**Economic and Social Council**Distr.: General  
22 September 2015

**Economic Commission for Europe****Inland Transport Committee****World Forum for Harmonization of Vehicle Regulations****Working Party on Passive Safety****Fifty-eighth session**

**Regulation No. 129 (Enhanced Child Restraint Systems)****Proposal for the 02 series of amendments to Phase 2 of  
Regulation No. 129 (Enhanced Child Restraint Systems)****Submitted by the expert from France\***

The text reproduced below was prepared by the expert from France. It introduces the 02 series of amendments to UN Regulation No. 129 (Enhanced Child Restraint System (ECRS)) that were agreed upon by the experts of the Informal Working Group on Child Restraint Systems (IWG CRS). It supersedes ECE/TRANS/WP.29/GRSP/2015/09 and it is based on an informal document GRSP-57-20 distributed at the fifty-seventh session of the Working Party on Passive Safety (GRSP). The modifications to the existing text of the UN Regulation, including the draft 01 series of amendments (ECE/TRANS/WP.29/GRSP/2015/24), are marked in bold for new or strikethrough for deleted characters.

*Annex 2, insert at the end two new approval marks, to read:*

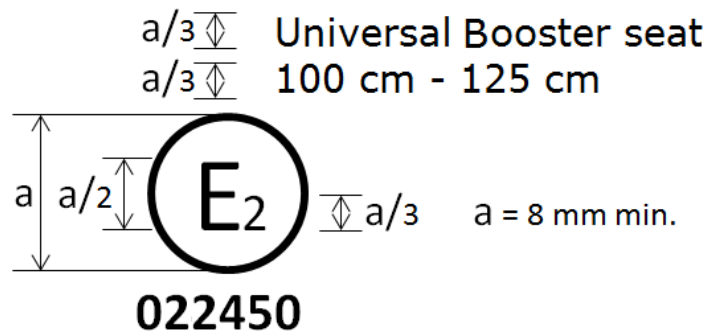
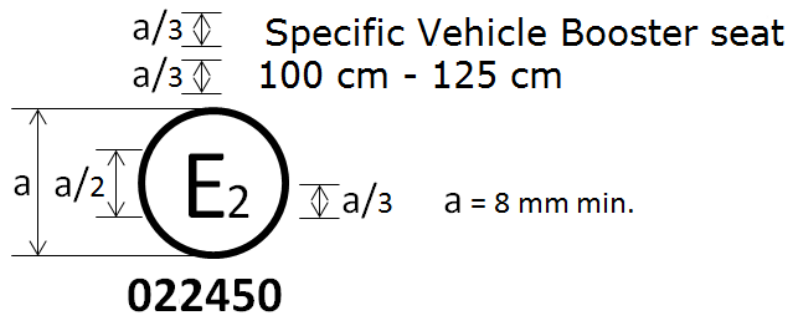
The Enhanced Child Restraint System bearing the above approval mark can be fitted in any universal booster seating position and used for the 100 cm - 125 cm size range; it is approved in France (E 2) under the number 022439. The approval number indicates that the approval was granted in accordance with the requirements of the Regulation concerning the approval of Enhanced Child Restraint Systems used on-board of motor vehicles as amended by the 02 series of amendments. In addition, the name of the regulation is to be identified on the approval mark followed by the series of amendment according to which the approval has been granted.

The Enhanced Child Restraint System bearing the above approval mark is a device not capable of being fitted in every vehicle but capable of being used for the 105 cm - 135 cm size range; it is approved in France (E 2) under the number 012450. The approval number indicates that the approval was granted in accordance with the requirements of the Regulation concerning the approval of specific vehicle booster seat Enhanced Child Restraint Systems used onboard of motor vehicles as amended by the 01 series of amendments. In addition the name of the regulation has to be identified on the approval mark followed by the series of amendment according to which the approval has been granted."

Figure 1  
**Top View – Bench with ISOFIX anchorages (Tolerance general: ±2 mm)**

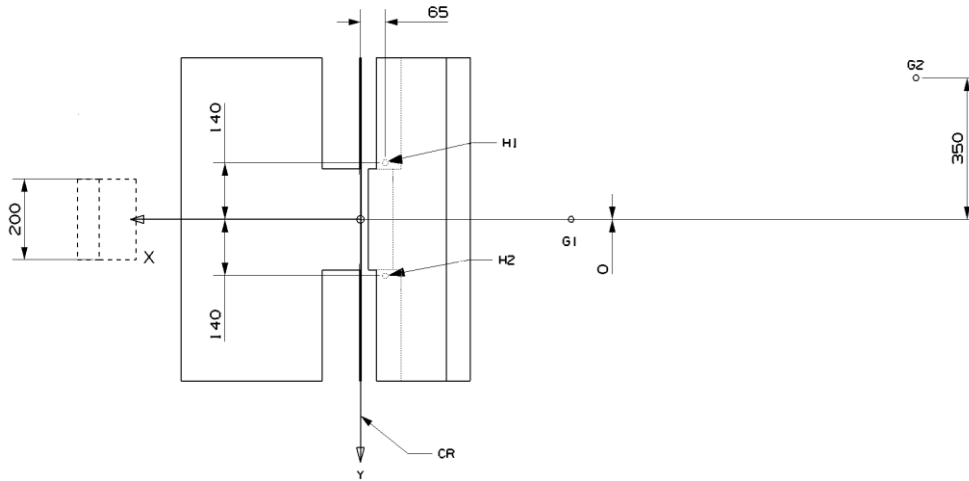
1. The anchorages shall be positioned as shown in the figure below.
2. Enhanced Child Restraint Systems in the i-Size "universal", "specific" and "restricted" categories shall use the following anchorage points: H<sub>1</sub> and H<sub>2</sub>.

Figure 3  
**Top View – Bench with belt anchorages (Tolerance general:  $\pm 2$  mm)**

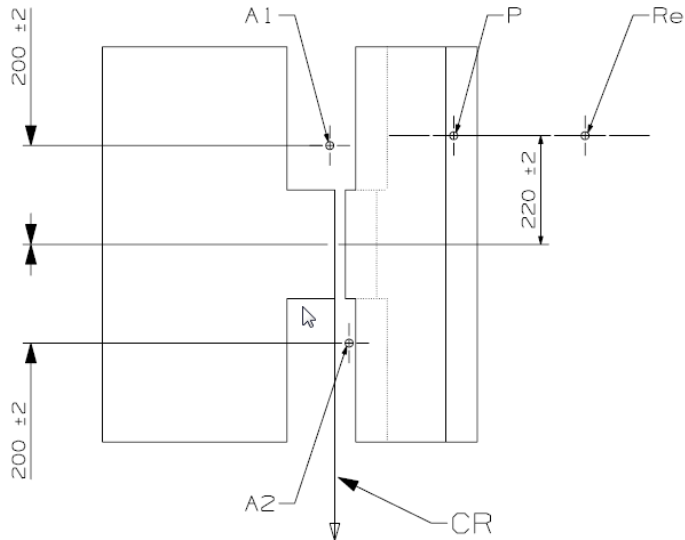
The following table gives the belt anchorages points.

"Re" is located on the centre line of the retractor spool

Figure 4  
**Side View – Bench with belt anchorages (Tolerance general:  $\pm 2$  mm)**

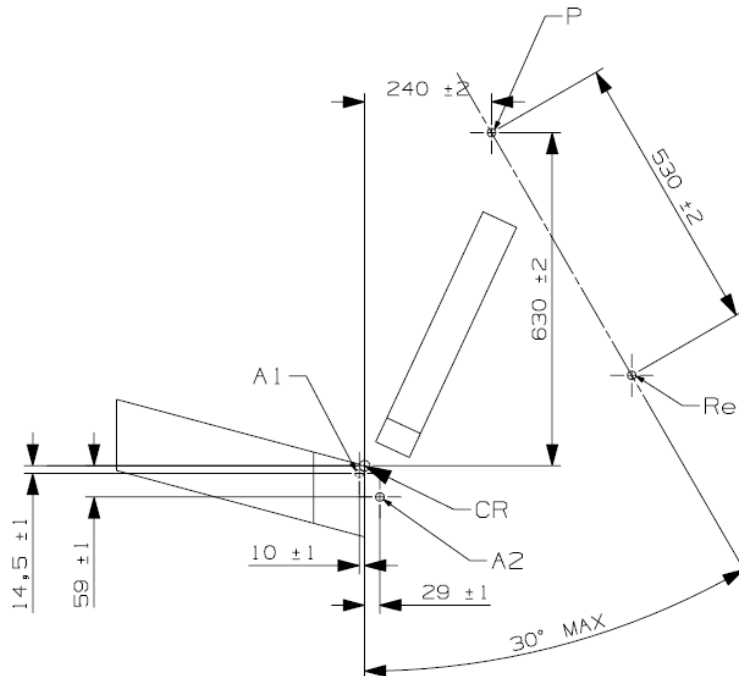
"Re" is located on the centre line of the retractor spool"

Figure 1  
Standard seat belt configurations

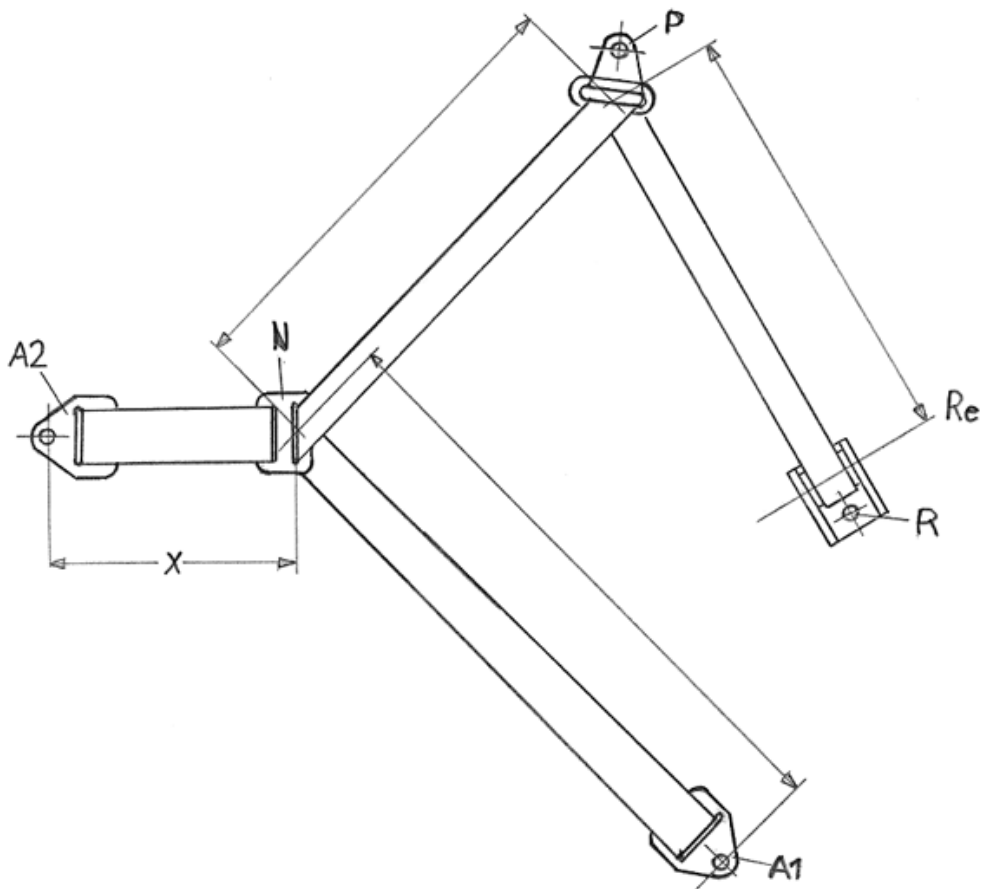
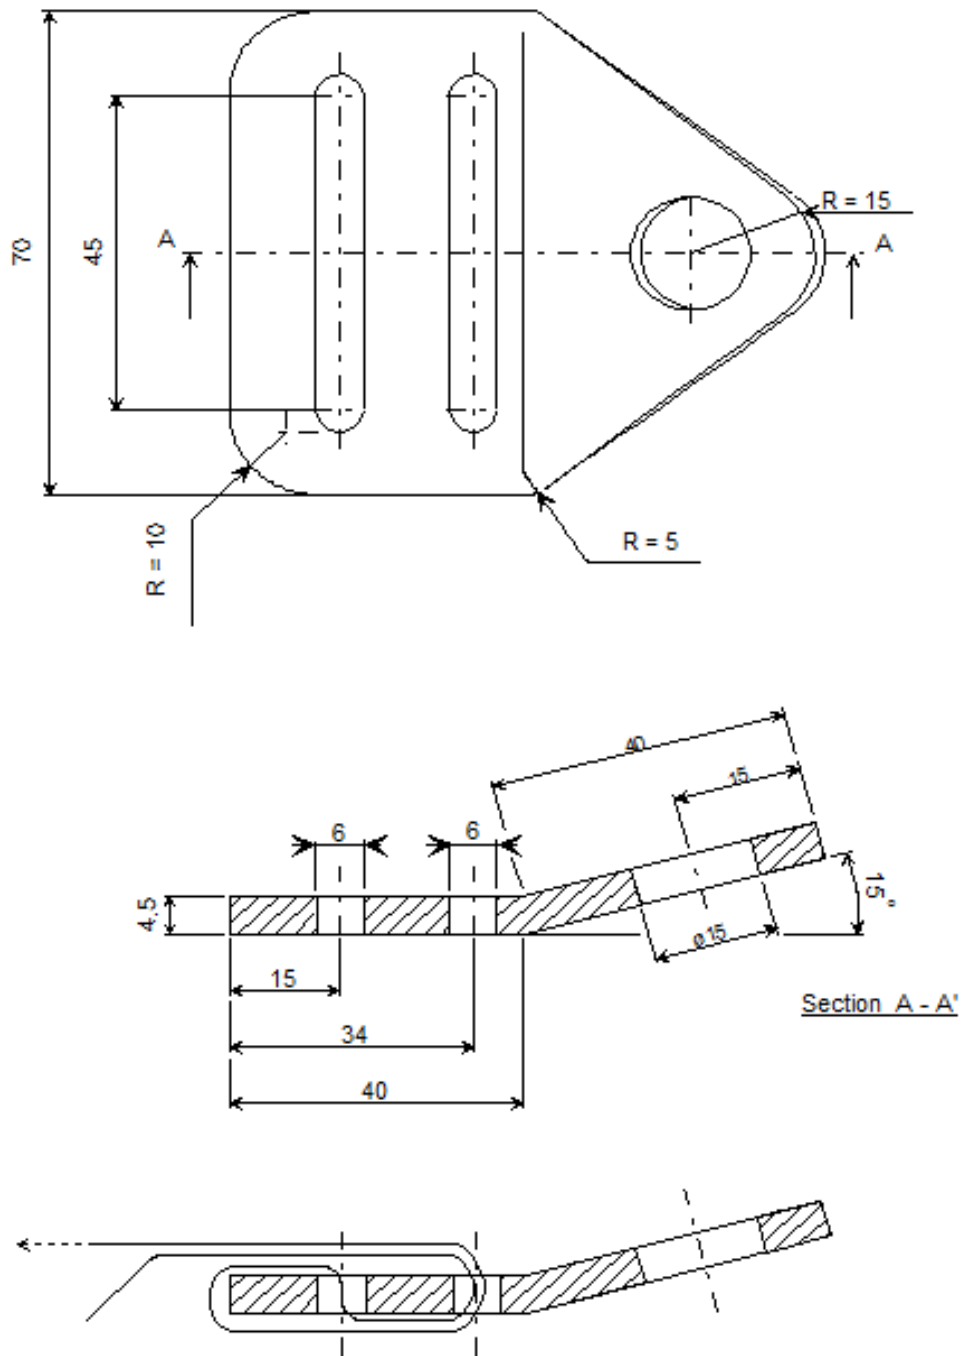
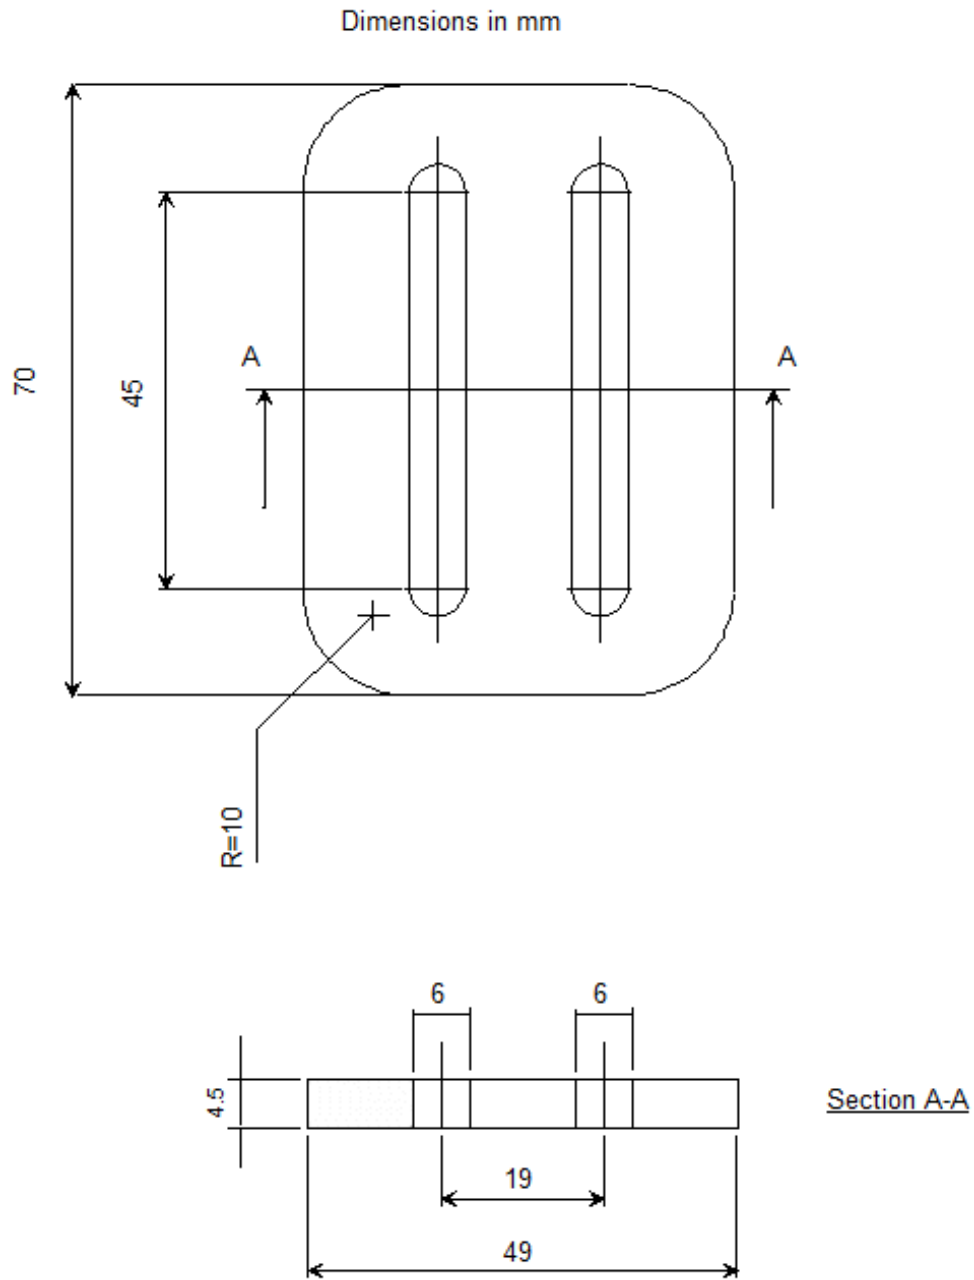
1. The safety-belt for the dynamic test and for the maximum length requirements shall be made according to the configuration shown in Figure 1. These are a three-point retracting belt system.

2. The three-point retracting belt has the following rigid parts: a retractor (R), a pillar loop (P), two anchorage points (A1 and A2) (see Figure 1), and a central part (N, in detail in Figure 3). The retractor shall comply with the requirements of Regulation No. 16 (paragraph 6.2.5.2.2.) for retraction force. The retractor spool diameter is  $33 \pm 0.5$  mm [(example is given in Mutual Resolution No. 1 (M.R.1))].

The value of X in Figure 1 below is  $200 \pm 5$  mm. The effective strap length between A1 and the centre line of the retractor spool Re (when the webbing is fully extracted including the minimum length of 150 mm for testing of Enhanced Child Restraint System shall be  $[2820] \pm 5$  mm when measured in a straight line without load and on a horizontal surface. This length may be increased for the testing of restricted categories; for all categories with the Enhanced Child Restraint System installed, there shall be a minimum of 150 mm of strap length on the retractor spool.
